UNITED STATES PATENT AND TRADEMARK OFFICE

APPLICATION NO.	FILING DATE	FIRST NAMED INVENTOR	ATTORNEY DOCKET NO.	CONFIRMATION NO.
09/941,154	08/27/2001	John R. Bianchi	RTI-112RIA	5282
75	90 10/31/2006		EXAM	INER
DONALD J. POCHOPIEN			PREBILIC, PAUL B	
MCANDREWS, HEKD & MALLOY, LTD.			ART UNIT	PAPER NUMBER
CITICORP CENTER, 34TH FLOOR 500 WEST MADISON STREET			3738	TATER NOMBER
CHICAGO, IL			3736	
•		DATE MAILED: 10/31/2006

Title: "Assembled Implant" Inventor: Bianchi, John R., et al.
Application No.: 09/941,154 Conf No.: 5282
Docket No.: RTI 112R IB /1915-13980US03
Attorney: Donald J. Pochopien
Telephone: (312) 775-8133

FIG. 1

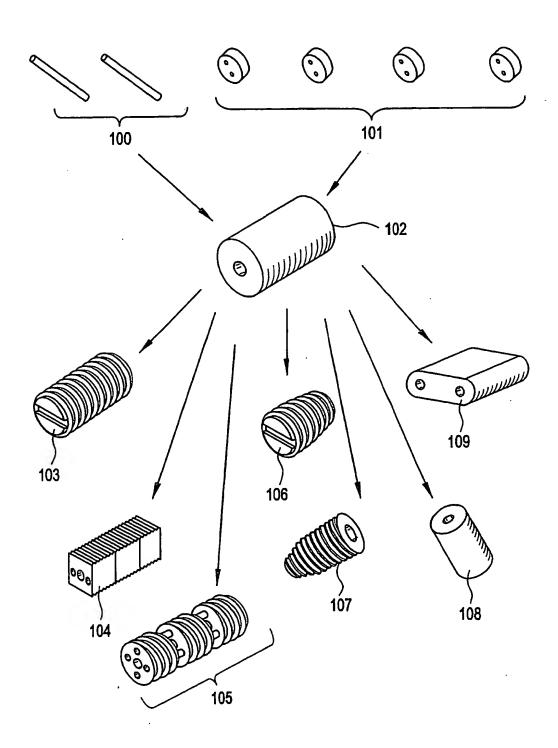
The replacement drawing sheets were received on August 7, 2006. These drawings are approved-in-part. The substitute drawings for Figures 28 to 30 have been accepted. However, the substitute drawings for Figures 1, 31A, and 32A to 34B have not been approved.

The drawings are objected to because they do not comply with Rule 84. Specifically, Figures 1, 32A, 32B, 33, 34A, and 34B have multiple views that are not numbered separately; bracketing different views of different embodiments is not acceptable (see 37 CFR. 1.84 (u) (1). Additionally, Figure 31A has lead lines pointing to empty space; see 37 CFR 1.84(q).

Not Approved PBP (0/23/06.

Corrected drawing sheets in compliance with 37 CFR 1.121(d) are required in reply to the Office action to avoid abandonment of the application. Any amended replacement drawing sheet should include all of the figures appearing on the immediate prior version of the sheet, even if only one figure is being amended. The figure or figure

FIG. 31A

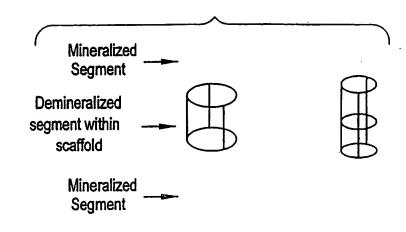
Not Approved
Approved
For entry
ppp
10/23/06

FIG. 32B

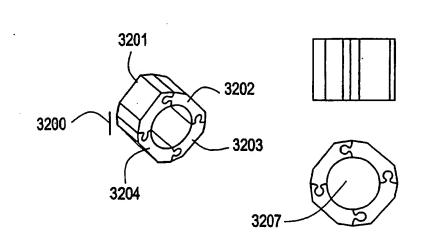
Not Approved for entry pBP. 10/23/06
